# Urban Design Peer Review

## Western Sydney University - Bankstown Campus Proposal

Prepared for City of Bankstown Canterbury

**Figure 43.** Lyons' Updated Ground Level Plan - Paul Keating Park Interface (Source: Lyons Updated Draft Architectural Drawings 5 (F 190814))

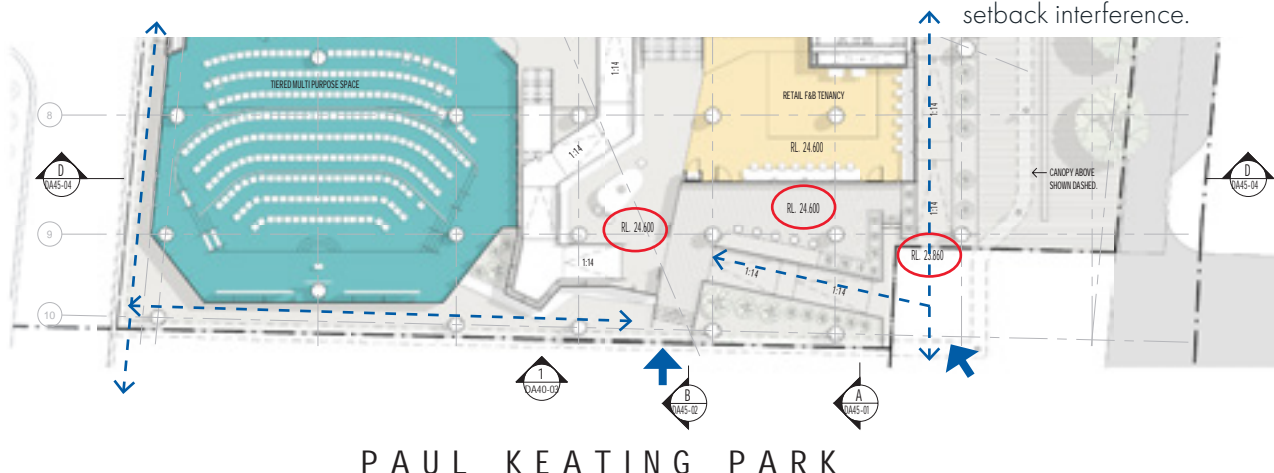
- The major pedestrian flows will arrive from Bankstown train station on the south via The Appian Way. Apart from The Appian Way entry lobby, there are two ground-level entries to WSU proposed along the Paul Keating Park interface. One is located at the south-east corner of the building, while the other is located toward the middle of the southern interface. Both entries correspond to the existing ground level. The level difference between internal and external are picked up by a series of ramps and steps, which offer smooth and equal access for all users. Refer to figure 43.
- Visual connectivity between WSU and the Paul Keating Park is enabled through the WSU entrances and ground level glazing facade.

- A ground-level colonnade is proposed along the Paul Keating Park interface to provide weather protection for the pedestrians and other users.

- Different functional spaces are programmed at the ground level alongside the Paul Keating Park interface. These include a multi purpose hall, entry lobby and retail spaces. These functional spaces provide great opportunities for activation and vibrancy on the ground level and provide passive surveillance to the Park.

**Figure 45.** Lyons' Updated Ground Level Plan - Rickard Road Interface (Source: Lyons Updated Draft Architectural Drawings 5 (F 190814))

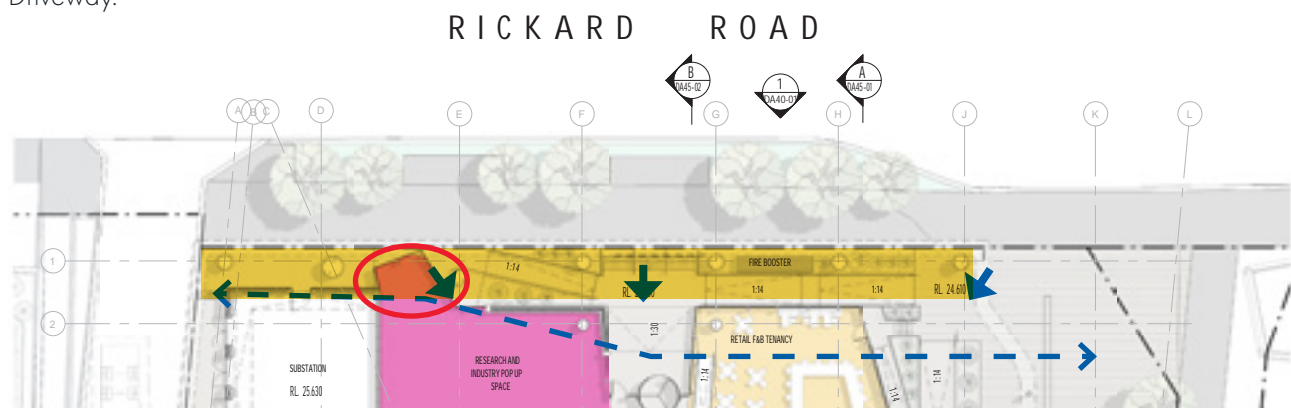
- There is a setback proposed at ground level on north side of WSU along Rickard Road, which provides the sense of alignment to both Council building on the east and the Bankstown Library and Knowledge Hub on the west.
- A series of ramps and steps are accommodated within the setback zone, which pick up the level difference between internal and external. This offers smooth and equitable access for all users. Refer to figure 45.
- A space intrudes into the setback zone, which interrupts the under-covered pedestrian movement through. It also conflicts with the design guidance of "2.3m wide pedestrian movement through within Lot Boundary" as suggested in *Bankstown Draft Complete Streets (April 2019)*. Refer to figure 44 and 45.
- Reconfiguration of the 'research and industry pop-up space' is required to avoid the front setback interference.

- Different functional spaces are programmed at ground level along Rickard Road, including university research and industry pop-up spaces, entry lobby and retail. These spaces provide additional opportunities for ground level activation and provide passive surveillance to Rickard Road.
